INDESIT company

Model type:
LV460AWH

Commercial code:
F030378

n1045085: Introduction of new litre counter turbine integrated on air-break.

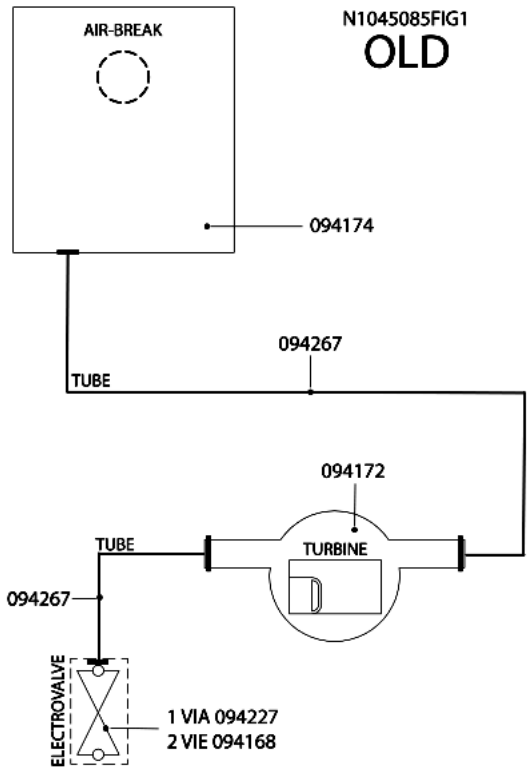
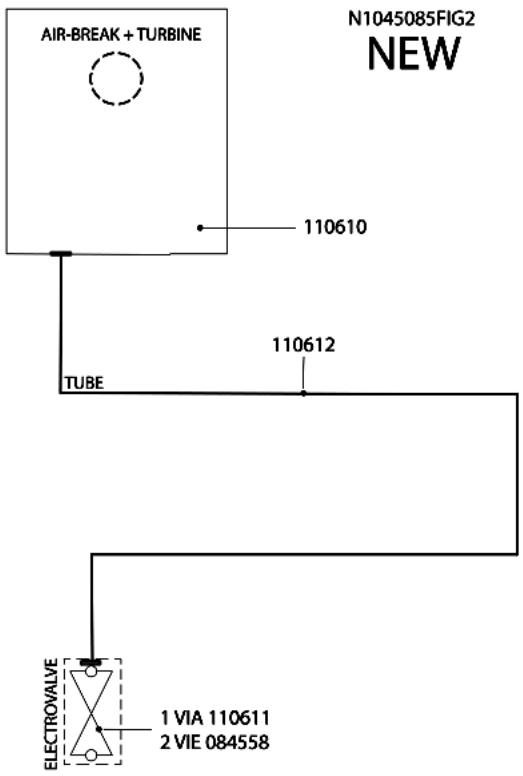
All dishwashers affected by this note have been equipped with a new litre counter turbine on the air-break.
Picture N1045085FIG1 illustrates the premodification structure, picture N1045085FIG2 the new structure.

AIR-BREAK:
new 110610;
premodification 094174;
the new item features a new integrated litre counter turbine and its water supply hose has a smaller diameter.

LITRE COUNTER TURBINE code 094172 has been eliminated.

SOLENOID VALVES:
new:
1-WAY code 110611;
2-WAY code 084558(Rohs 143737);
premodification:
1-WAY code 094227;
2-WAY code 094168;
the new solenoid valves have a smaller diameter drain hose fitting.

HOSES:
new solenoid valve hose/air-break code 110612;
premodification turbine hose/air-break code 094267;
premodification solenoid valve hose/air-break code 094267;
the new hose has a smaller internal diameter.

WIRING:
the litre counter turbine connecting cable is longer, but since the connector is the same, the new item can be used in place of the premodification one.

n1045087: Introduction of recessed heating element.

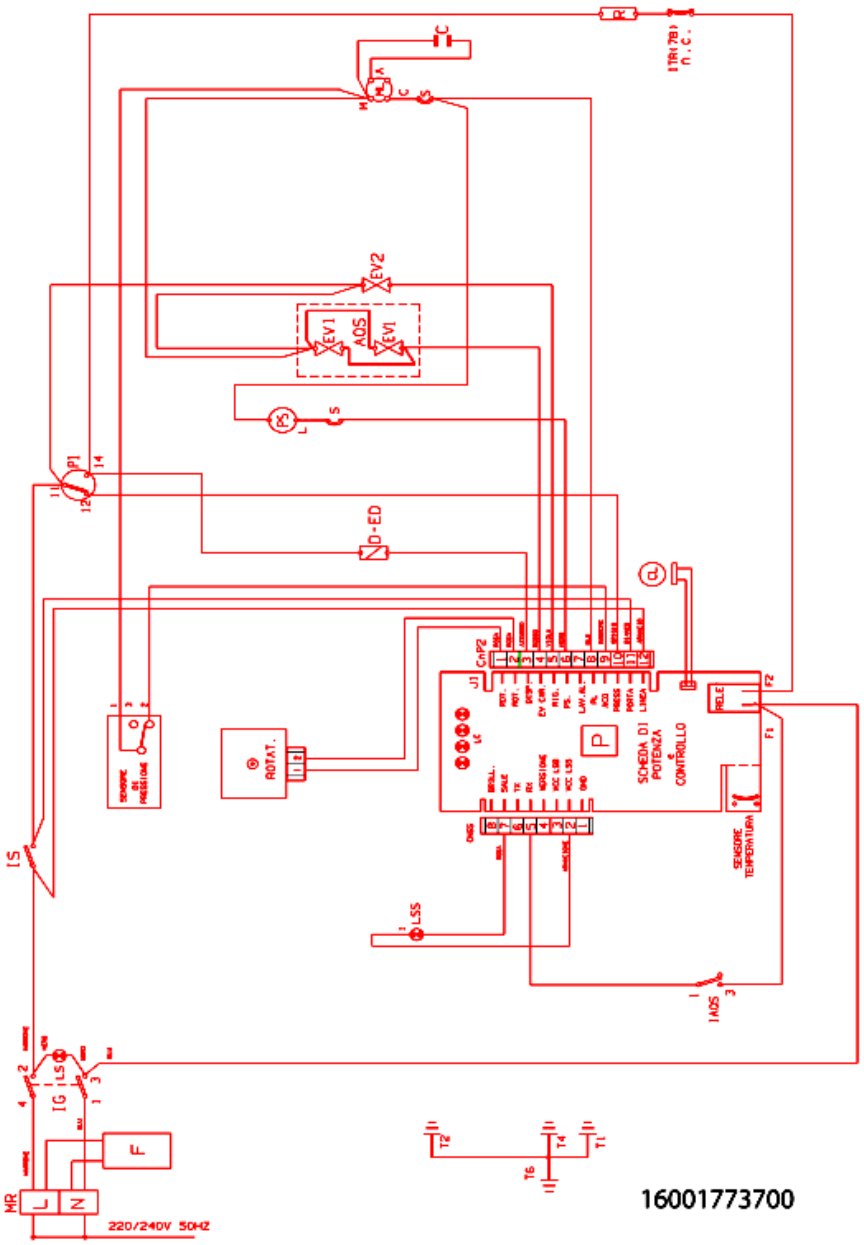
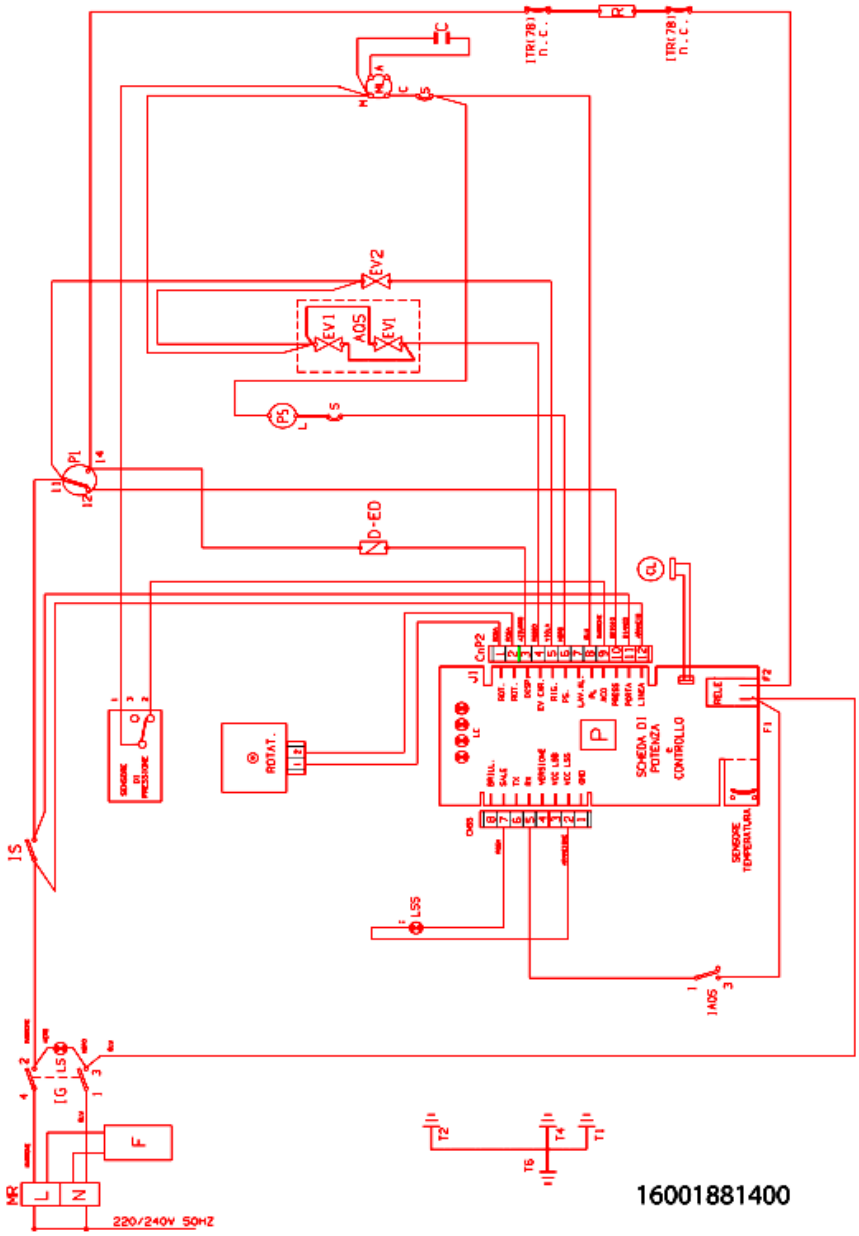
From serial no. 40624.0001, all dishwashers affected by this note have been equipped with a recessed heating element in place of the exposed one located inside the tank.
Given below are the codes of the items concerned:

ELIMINATED ITEMS:
nut + washer code 097871
o-ring seal code 063792
temperature probe code 063791
safety thermostat code 041086
exposed heating element code 066602
heater terminal protection code 074714
upper impeller supply tube code 056001
electrical pump connection tube - upper impeller supply tube code 076233
heater bracket code 054872

INTRODUCED ITEMS:
recessed heating element code 074000
upper impeller supply tube code 094152
heater coupling support code 078394
electrical pump connection tube - heating element code 057710

LV460AWH (comm. code 30378)
Wiring Diagram: premodification 16001773700 new 16001881400
Wiring: premodification 110482 new 112488
